CCK-0084-3-26

Entomology Research and Education Center

ADDENDUM #3

Addendum #3

Photo Location Plan

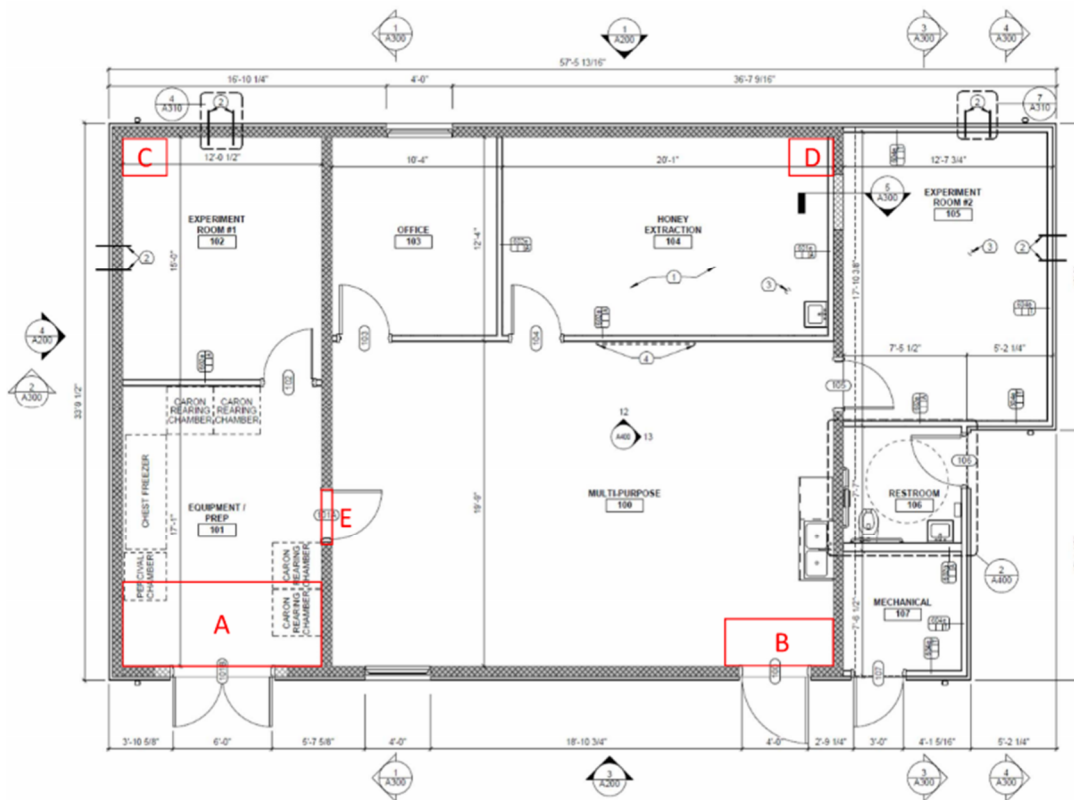
27. The concrete slab at the overhead door is badly cracked and settled. Please provide clear directions on how to remedy this problem.

A: Refer to photo plan and photos for areas in which concrete is in need of repair.

In areas C and D: Infill with concrete. Add rebar to existing concrete for the new concrete pour.

In areas A, B, E: Cut out slab. 4" slab fill with 4" x 4" x 0.25 WWM.

DETAIL @ BASE CABINET SINK

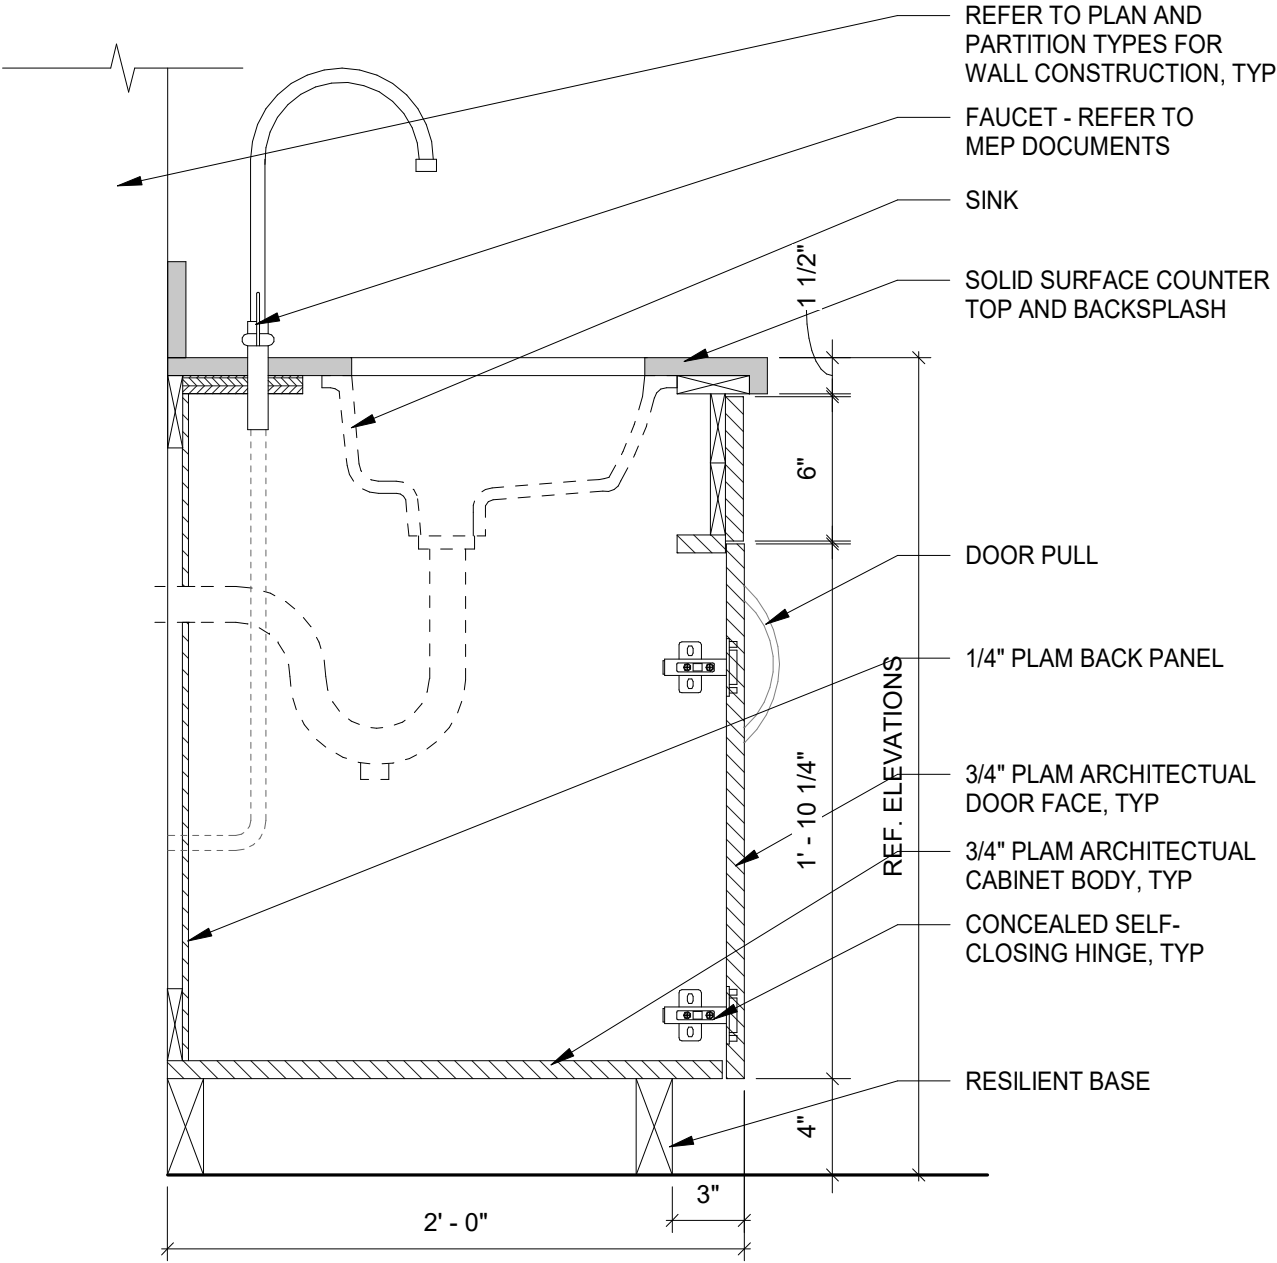
5. Please provide a spec and finish selection for the casework shown in Multi-Purpose Rm 100.

A: Refer to drawings in this document labeled "ATTACHMENT B" sheet A622 and A623.

SITE UTILITY DETAILS AND SCHEDULES

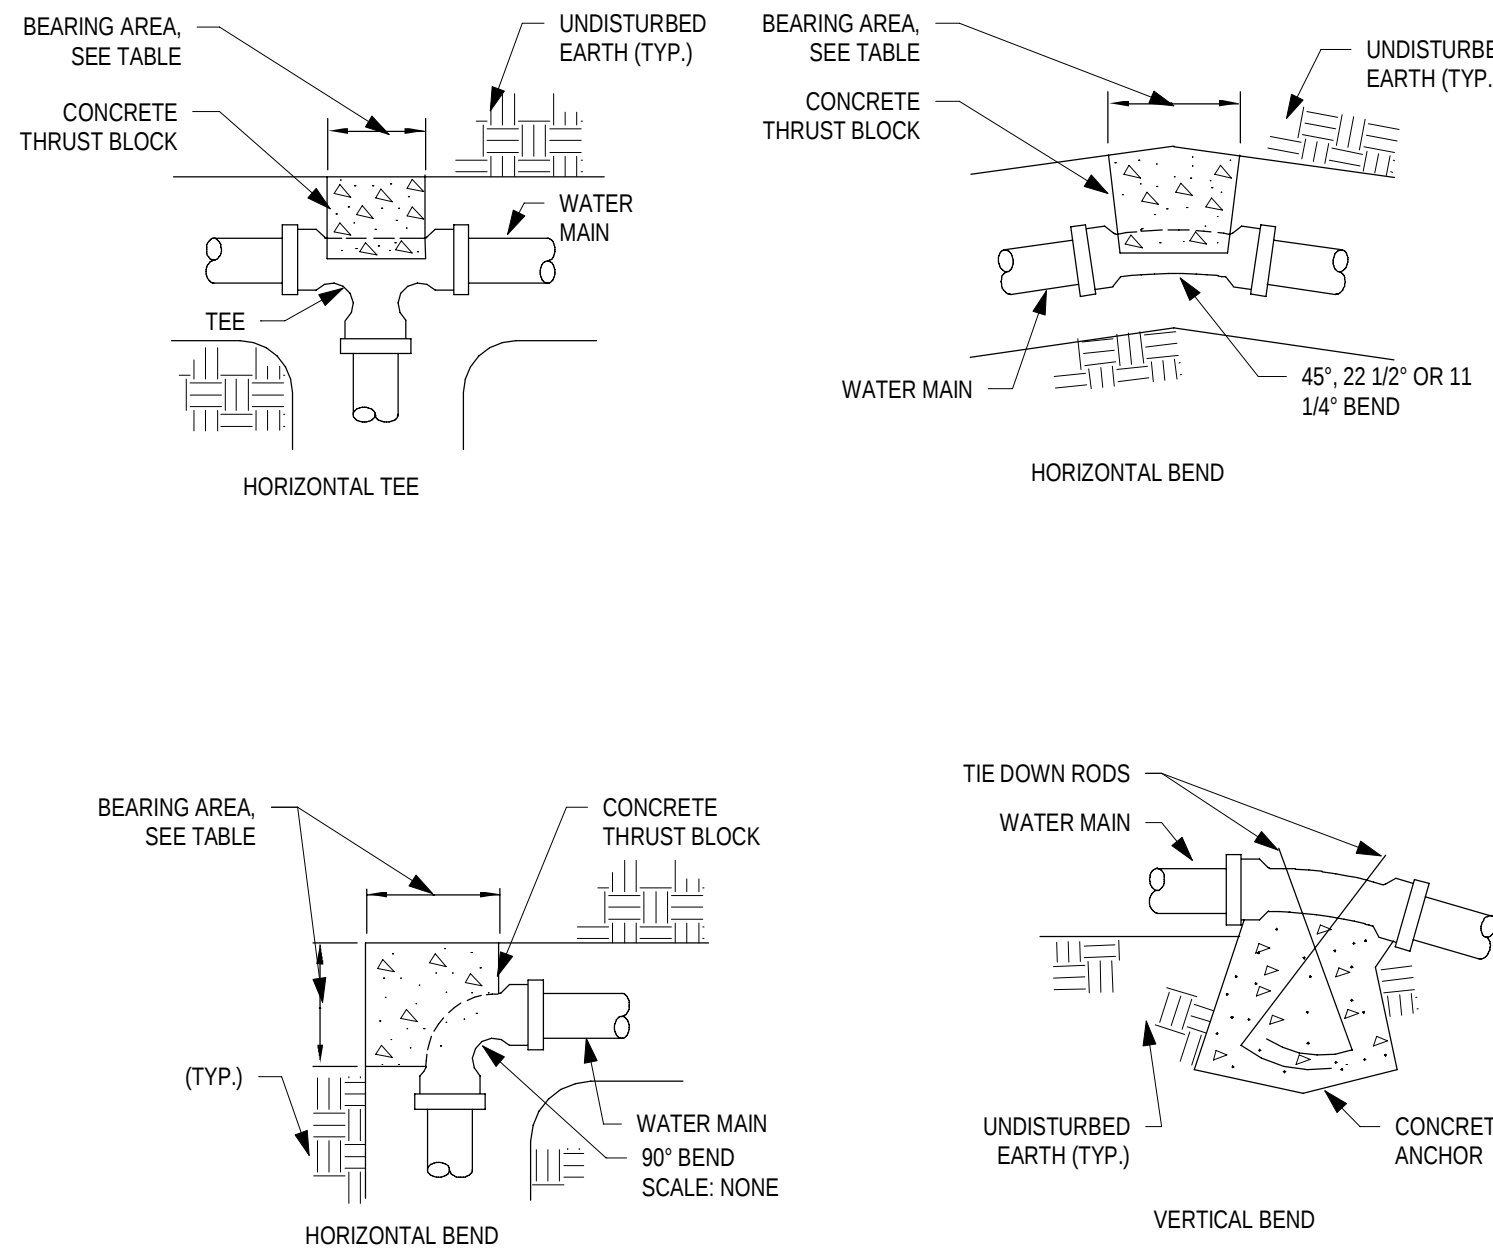
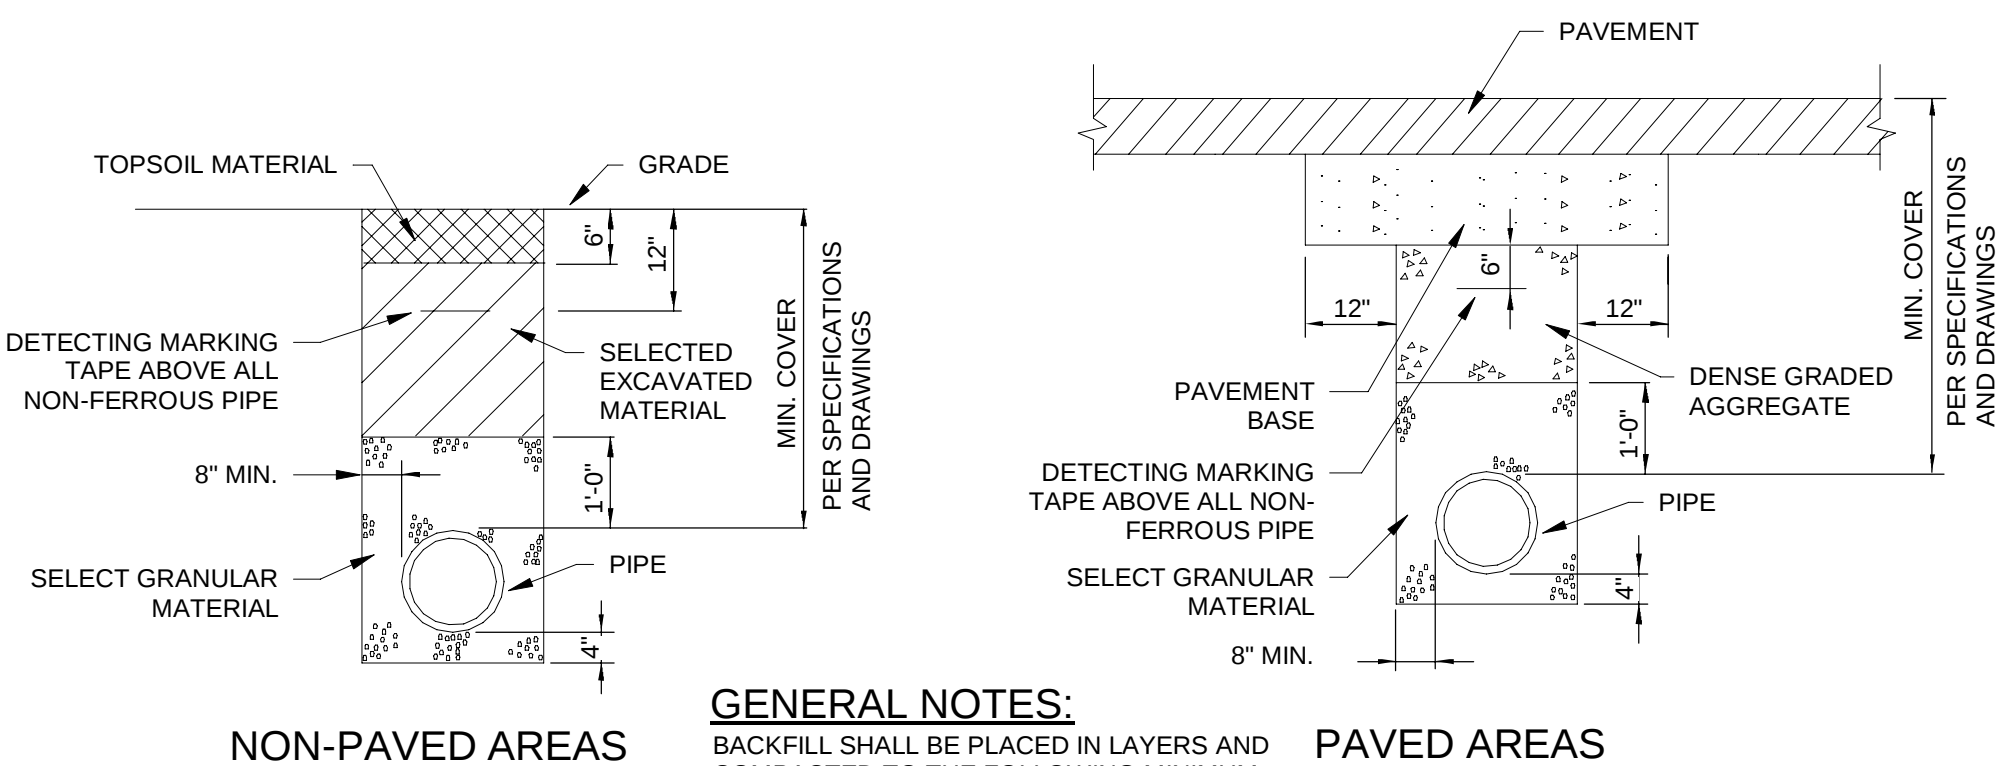
3. Per SU102 - Site utility owner is responsible for providing power conduits between meter base and electric utility pole.

33. Who will pull new power and communications into the building?

A: The utility company will provide the wiring between the meter base and the utility pole. We will revise the electrical service scope / responsibilities in an upcoming addendum. The contractor, not the owner, shall provide the conduit b/w the meter base and utility pole to provide a complete electrical system to the building.

A: Refer to the "Site Utility Owner VS. Contractor Responsibilities" notes on Drawing SU102. All power from the meter into the building is contractor responsibility. The owner will pull all communication cabling, the contractor is responsible for the associated data conduit rough-in.
